**STAFF REPORT: 7/14/2021 MEETING**

**APPLICATION NUMBER: #21-7359**

**ADDRESS: 119 GARFIELD STREET**

**SCOPE: REVISION OF PREVIOUSLY APPROVED, MIXED-USE BUILDING DESIGN  
(WORK COMPLETE)**

**1 SOUTH ELEVATION- GARFIELD STREET**  
1/8" = 1'-0"

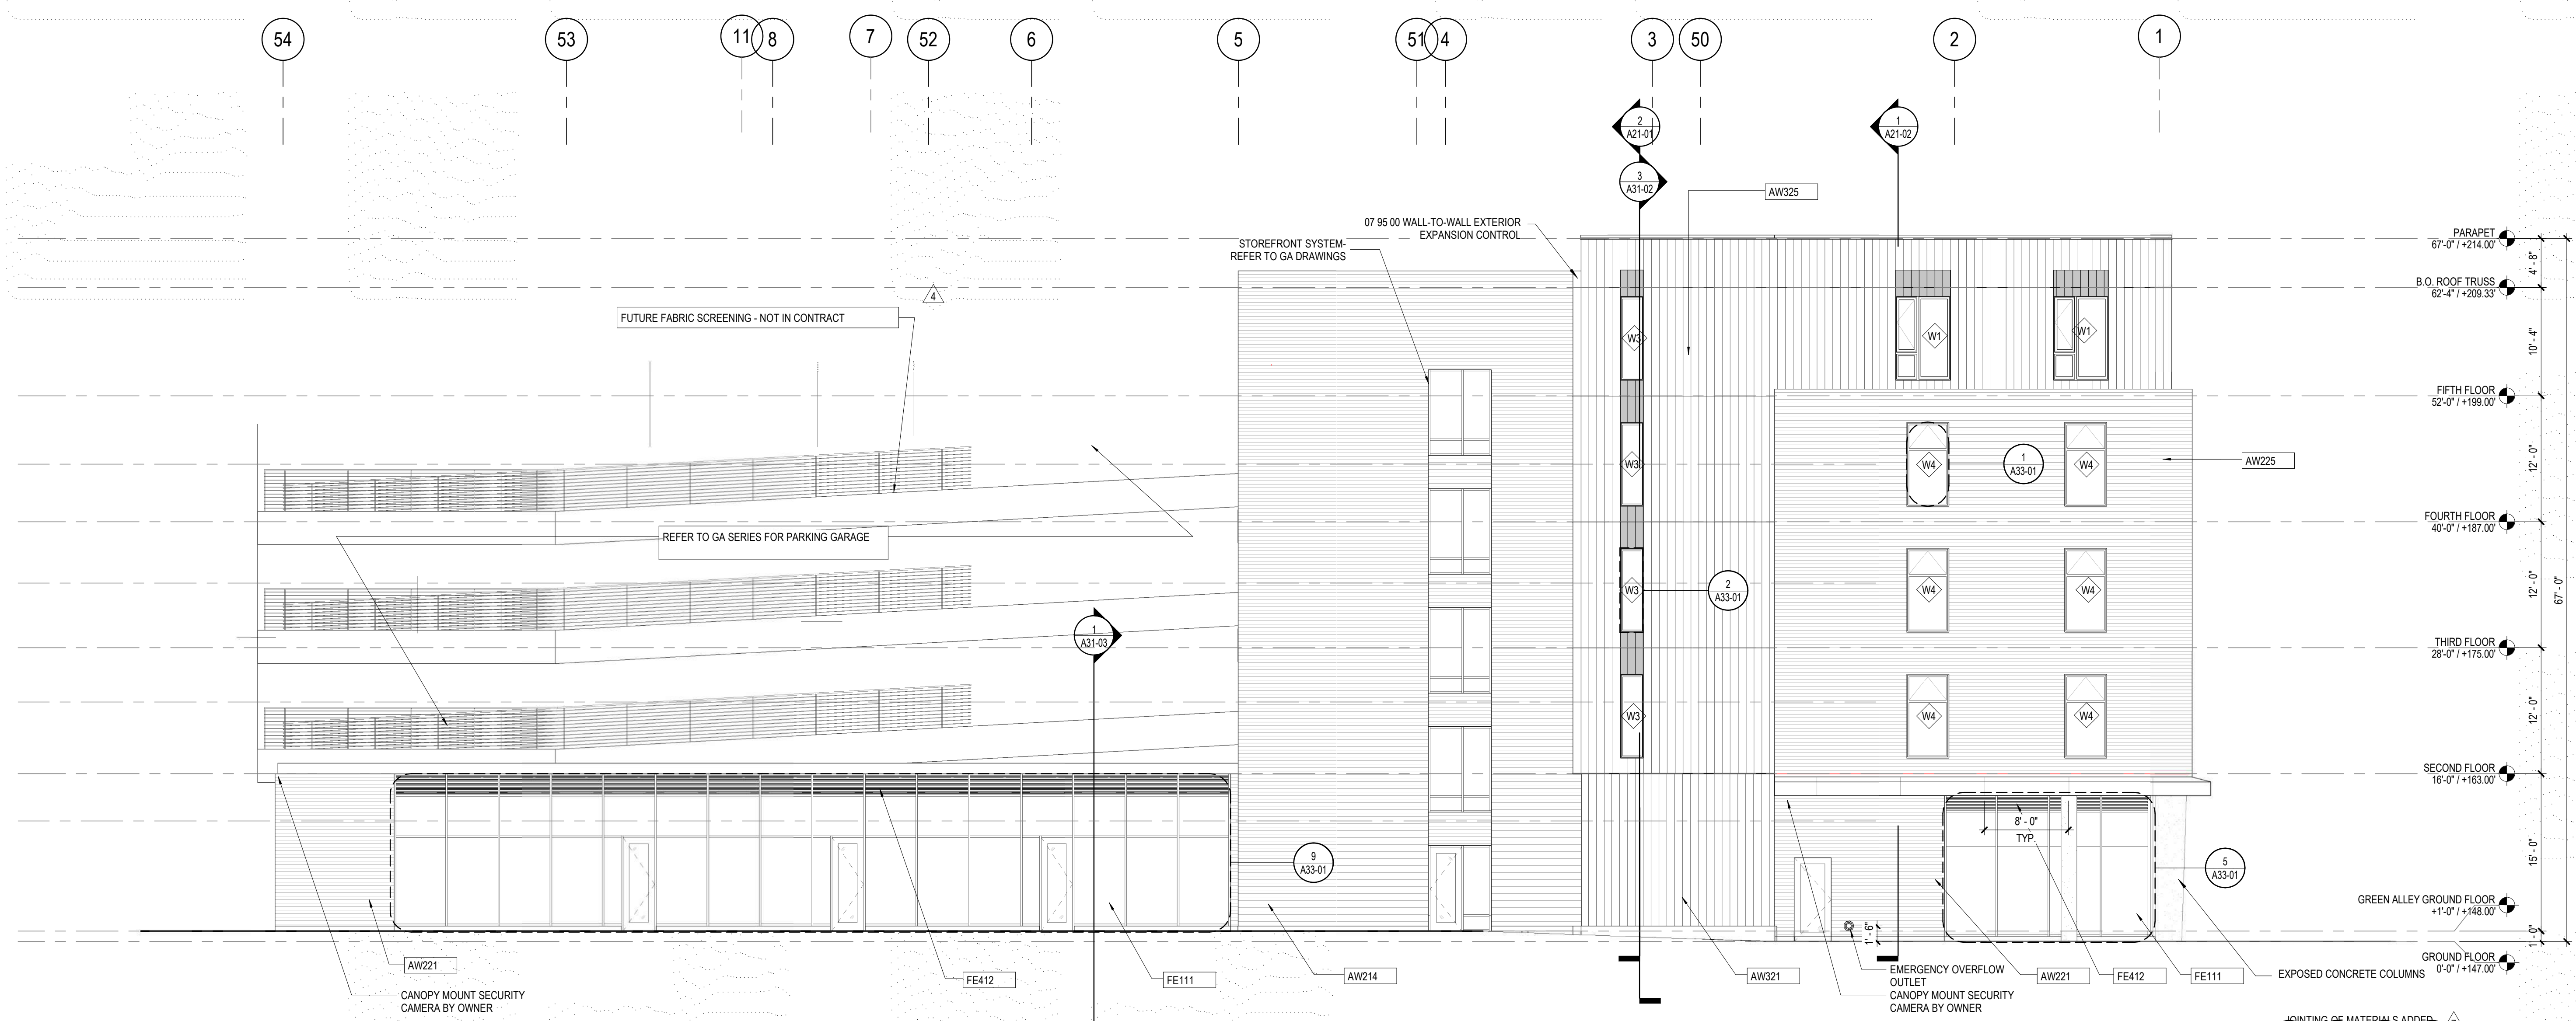
ELEVATIONS REVISED FOR VERTICAL SIDING  
REVISION- INCLUDING WINDOW REVISIONS

**2 WEST ELEVATION- GREEN ALLEY**  
1/8" = 1'-0"

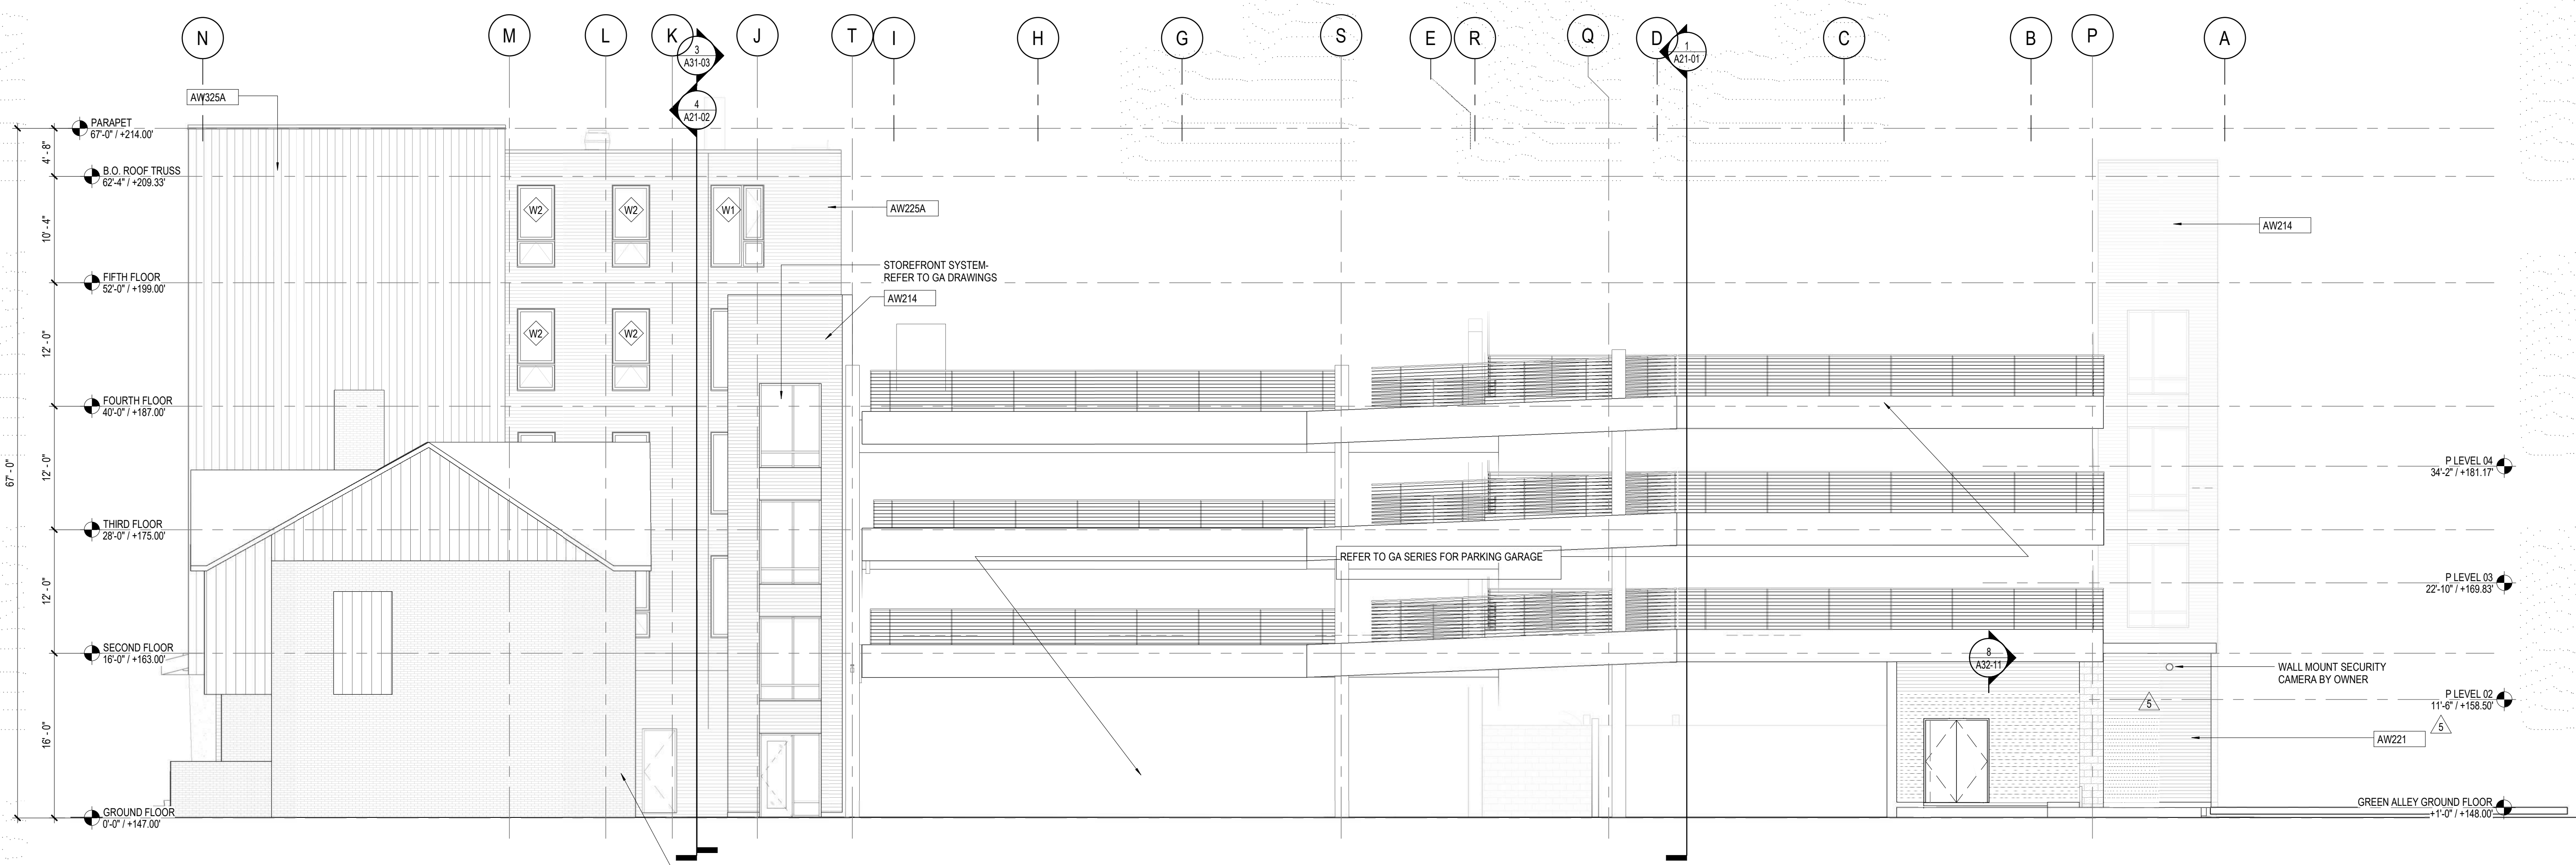
ELEVATIONS REVISED FOR VERTICAL SIDING  
REVISION- INCLUDING WINDOW REVISIONS
